Access Compliance Report

Public Rights-of-Way

(Curb Ramps)

Intersection ID: 13857	Main Street: ALBEMARLE_RD	Cross Street: DENBUR_DR	Location: W
ADA ID: DBDC788D3324	Ramp Type: Perp	Initial Pass/Fail: Fail	Overall Compliance: No
Severity Score: 21.25			
Codes/Mitigation Info/Possible Solution		Field Measurements/Component Compliance

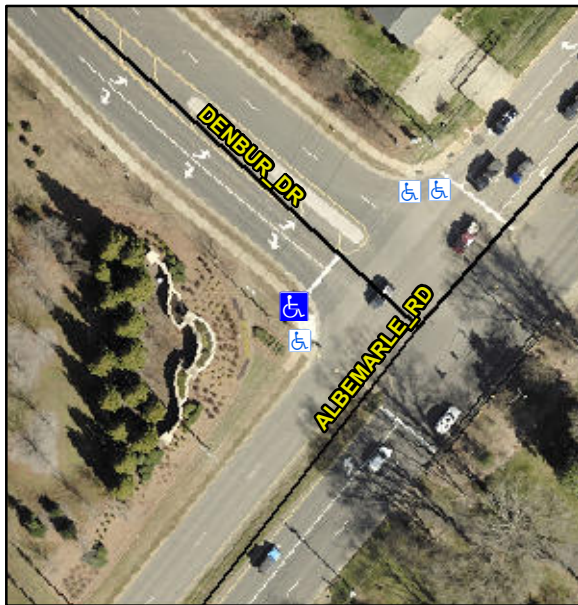
Not Found, R304.5.1, R304.2.2

Compliance	Description	Data	Compliance	Description	Data
N/A	Ramp Length (in)	50.0	No	Ramp Slope (%)	11.5
No	Ramp Width (in)	47.0	Yes	Ramp XSlope (%)	1.8
N/A	Flare Type LT	N/A	N/A	Flare Type RT	N/A
N/A	Flare Slope LT (%)	N/A	N/A	Flare Slope RT (%)	N/A
N/A	Flare Traversable LT?	N/A	N/A	Flare Traversable RT?	N/A
N/A	Landing Length (in)	N/A	N/A	DWS Provided?	N/A
N/A	Landing Width (in)	N/A	N/A	DWS Contrast?	N/A
N/A	Landing Slope (%)	N/A	N/A	DWS Length (in)	N/A
N/A	Landing X Slope (%)	N/A	N/A	DWS Full Width?	N/A
N/A	Landing Curb? (Y/N)	N/A	N/A	DWS Offset (in)	N/A
N/A	Shared Landing?	N/A			
N/A	Gutter Ponding?	N/A	N/A	Gutter Slope (%)	N/A
N/A	Gutter Lip Ht (in)	N/A	N/A	Gutter X Slope (%)	N/A
N/A	Painted X Walk1?	No	N/A	Painted X Walk2?	N/A
	X Walk 1 Direction	To NE		X Walk 2 Direction	N/A
N/A	X Walk 1 Width (in)	N/A	N/A	X Walk 2 Width (in)	N/A
	X Walk 1 Slope (%)	0.5		X Walk 2 Slope (%)	N/A
	X Walk 1 X Slope (%)	1.4		X Walk 2 X Slope (%)	N/A

Remove & Replace Entire Ramp.
